Spare Parts Requirements for High-Voltage Battery – Observe Additional Measure Required (34/21)

Revision: This bulletin replaces bulletin Group 2 34/21, dated April 5, 2021.

Model Line: **Taycan (Y1A)**

Concerns: **Damping elements for high-voltage battery**

Front damping elements

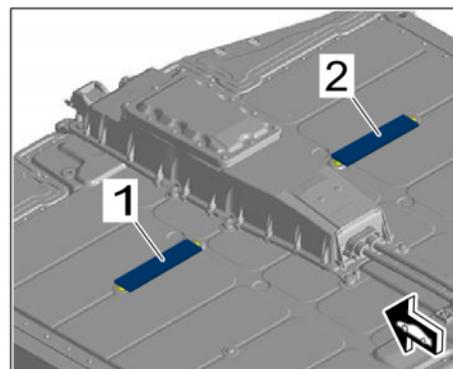
Work Procedure: 1 Check whether damping elements are installed on the high-voltage battery at the front left ⇒ *Front damping elements -1-* and right ⇒ *Front damping elements -2-*.

New damping elements must **not** be affixed if damping elements were not previously affixed. Otherwise, the high-voltage battery or underbody could be damaged.

Front left damping elements

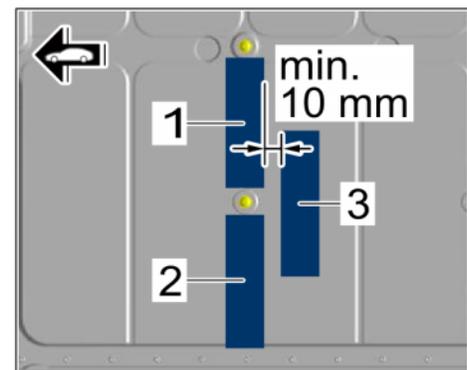
3 Position the first damping element ⇒ *Front left damping elements -1-* in the middle between the screws and stick it on.

- Never affix damping elements over the screws as they must remain accessible.
- The damping elements must be pressed into existing depressions and pressed on all the way around.
- The individual damping elements must be **at least 10 mm/ 0.39 in** apart.

4 Position the second damping element ⇒ *Front left damping elements -2-* at the left next to the screw and stick it on.

5 Position the third damping element ⇒ *Front left damping elements -3-* in the middle under the screw and stick it on.

Work Procedure: 1 Shorten nine damping elements (240 x 60 x 3 mm/ 9.45 x 2.36 x 0.12 in) to a length of 177 mm/ 6.97 in.

2 Stick three damping elements (177 x 60 x 3 mm/ 6.97 x 2.36 x 0.12 in) flush with each other. Three damping elements (element = stack of 3 pads) must then be installed on each side of the high-voltage battery even if only one damping element was affixed on each side of the old high-voltage battery.

- All sections of pads will be in stacks of 3 (will be 9mm/ 0.36 in thick when stacked together)
- This means 9 pads are used on each side; 18 per battery.

6 Repeat these steps for the right side.
